NOTICE OF MEETING
PLANNING AND ZONING COMMISSION
6:00 P.M. – September 15, 2022

PLANNING AND ZONING COMMISSION ITEM:
PC-22-27
PRELIMINARY PLAT
MITCHELL TRACT

REVIEW MEMORANDUM

SUBJECT: Mitchell Tract Preliminary Plat Review
PC-22-27
Preliminary Plat Acceptance Letter

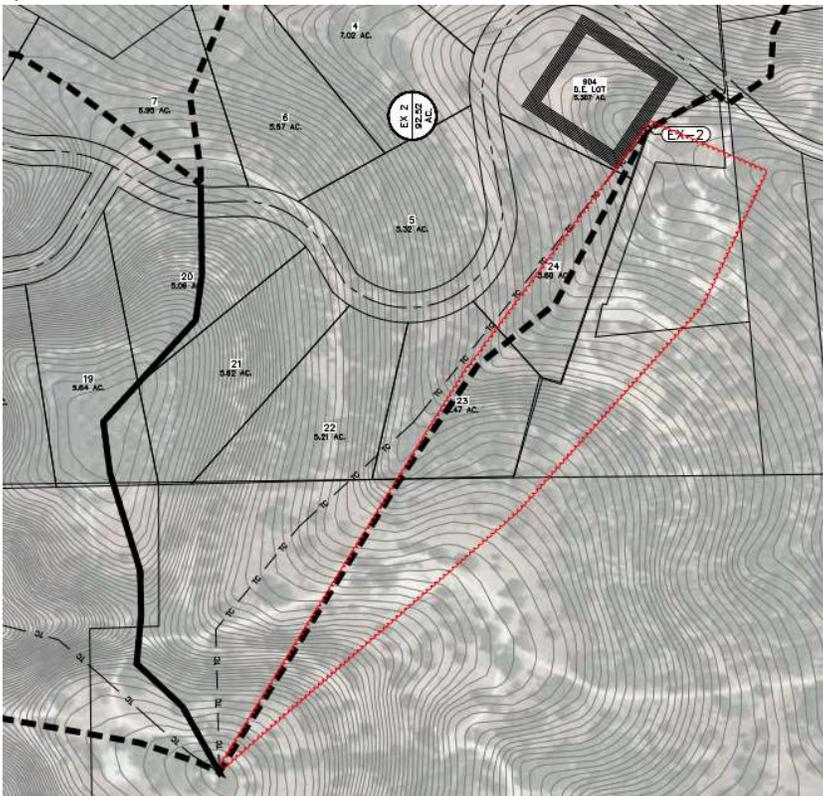
37. Plat boundary differs from Comal County Appraisal District website information at the connection point to Mitchell Drive. Please ensure accurate boundary information is presented on the plat and full access to Mitchell Drive is available for roadway extension. *8/23 Property line appears more clear, however the stated overall plat acreage did not change. Please provide deed(s) to confirm what is shown. 9/6 Comment resolved*
